SUBJECT: Service Instruction M20-88A - STABILIZER TRIM STOP/SCREW MODIFICATION  
Dated 12/14/2016.

SERVICE INSTRUCTION M20-88A  
Date: December 14, 2016

SUBJECT: STABILIZER TRIM STOP/SCREW MODIFICATION

INTRODUCTION: This Revision Supersedes M20-88 Dated 5/1/1990

**Figure SI M20-88-1**

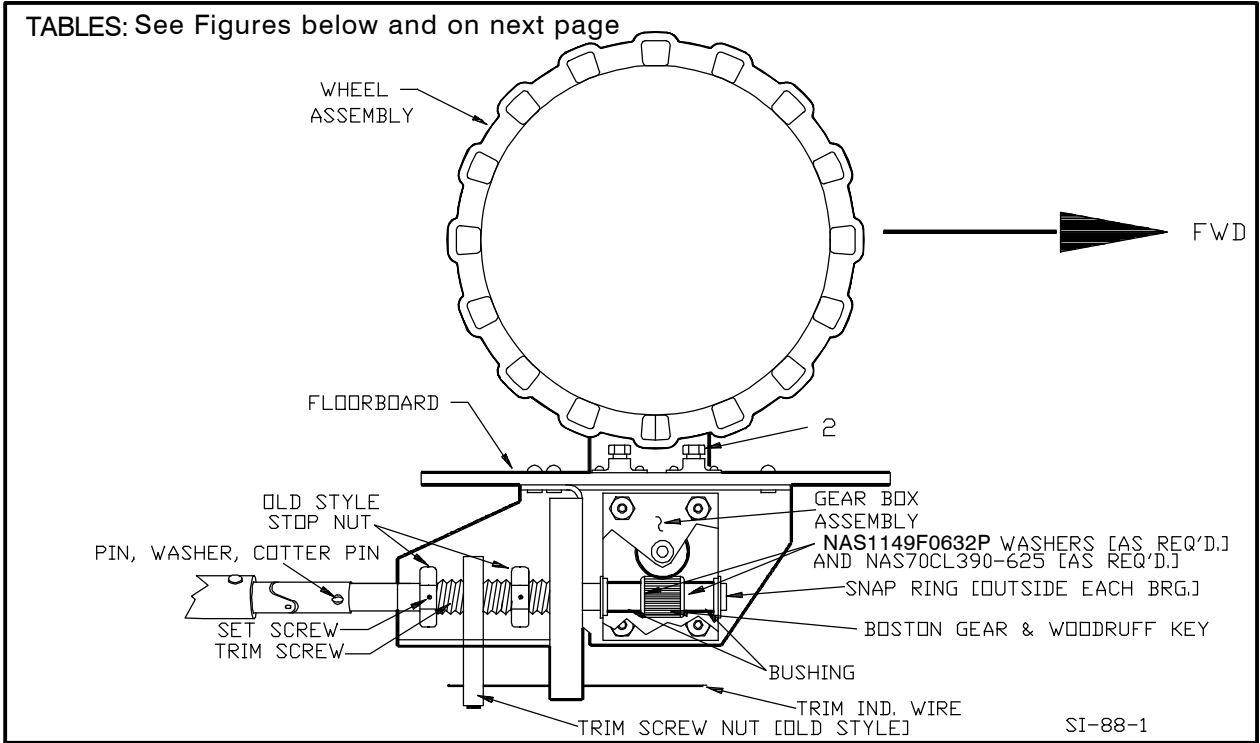
4. Remove cotter pin, washer and pin that secures trim tube universal joint to trim screw (Figure SI M20-88-1).
5. Loosen gear box bolts (Index 1, Figure SI M20-88-2) if not already done, and both NAS428-3-4 bolts (Index 2, Figure SI M20-88-2) to give slack in roller chain between upper and lower sprocket of trim control wheel assembly.

7. Remove roll pin, P/N RPA52-028-125-1125 holding lower sprocket, P/N 740049, to gear box shaft. Remove sprocket.
8. Loosen set screw, #6-32 x 1/8, in each existing trim stop so they will unscrew easily. Remove aft trim stop (DN stop) from trim screw (Fig. SI M20-88-1).

12. Measure and document longitudinal free play in trim screw shaft (end play) as assembled in the gear box assembly.
13. Remove forward snap ring from trim screw. Reference Figure SI M20-88-1
14. Lightly tap trim screw at forward end, with a plastic mallet, to drive trim screw, bushings, washers, gear and aft bearing from gear box assembly housing. Bearings are installed with loctite (Blue) at assembly, so some effort may be required to break it loose. **DO NOT DAMAGE BEARING OR HEATING THE HOUSING.**
15. When existing trim screw, and components attached to it, comes free from gear box housing, the bushings, washers, gears, woodruff key, snap ring and aft bearing will be removed. Retain components, except woodruff key, to place back on new trim screw (Fig. SI M20-88-1).

16. Install existing snap ring, P/N NAS51-37 on mid groove of new trim screw, P/N 740016-019. Re-assemble shim(s), bearing, bushing, washer(s), Boston gear, new woodruff key, washer(s) and spacer on new trim screw.

**Figure SI M20-88-2**

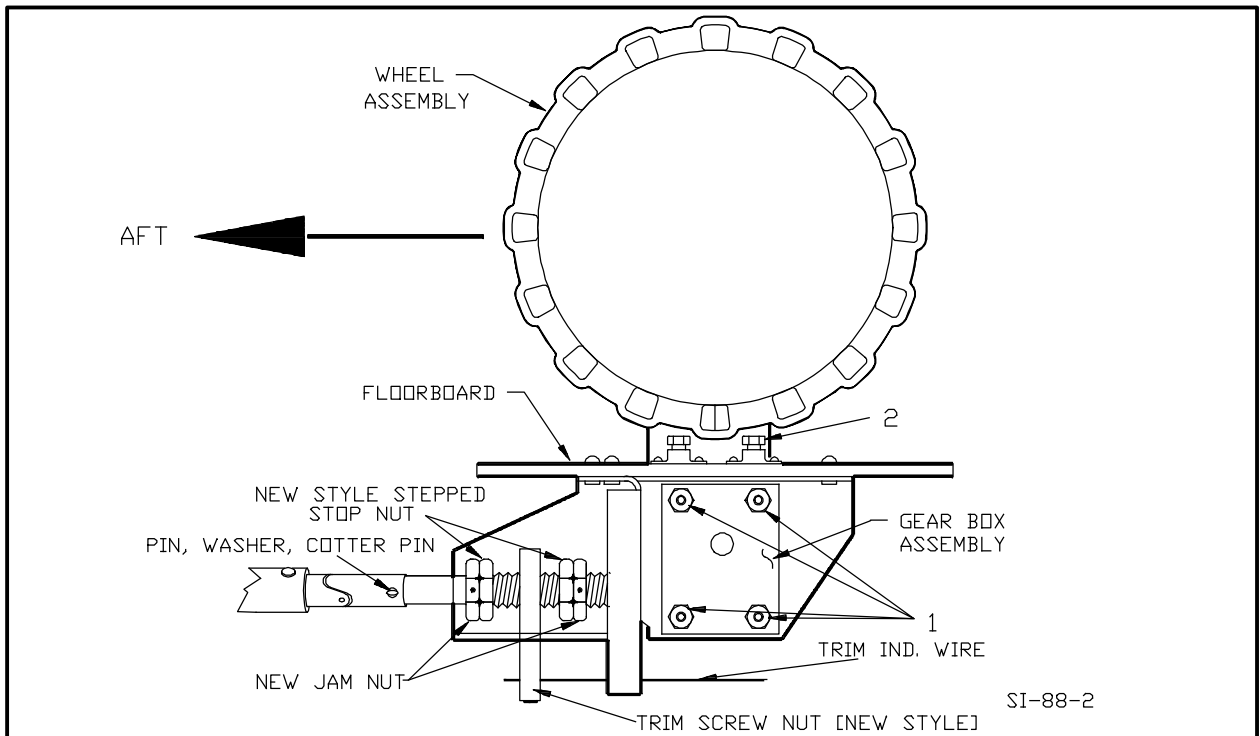
1. Remove belly access panels or smooth belly fairing to gain access to lower side of the trim control wheel assembly.
2. Remove trim indicator wire from trim screw nut by loosening set screw(s) that restrain trim wire.
3. Remove any brackets connected to gear box bolts (Index 1, Figure SI M20-88-2) both sides if required. Different models have different type of brackets.

22. Install one jam nut (UP stop side), P/N 740086-003 (M20J) or 740086-001 (M20K, M20L or M20M), on trim screw. Screw toward gear box housing leaving approximately 0.375 inch gap on threads between gear box and jam nut (Figure SI M20-88-2).
23. Install one stepped stop nut (UP stop), P/N 740086-007 (M20J) or 740086-005 (M20K, M20L or M20M) on trim screw. Screw toward gear box housing and against jam nut installed in step 22.

24. Position gear box/trim screw assembly to lower trim wheel assembly so new trim indicator nut, P/N 740086-011 (M20J) or 740086-009 (M20K, M20L or M20M) can be placed on trim screw and screwed in place to proper position within slotted bracket area. This is the reverse of Steps 9 & 10.
25. Install other stepped stop nut (DN stop) (stepped side toward trim indicator nut) on trim screw.
26. Install other jam nut on trim screw against stop nut (DN stop).
27. Reverse Steps 2 thru 7 to reposition gear box assembly back on trim wheel assembly. Do not tighten trim indicator wire set screw at this time. Position all other brackets but do not tighten bolts holding gear box assembly to trim wheel assembly (Fig. SI M20-88-2).
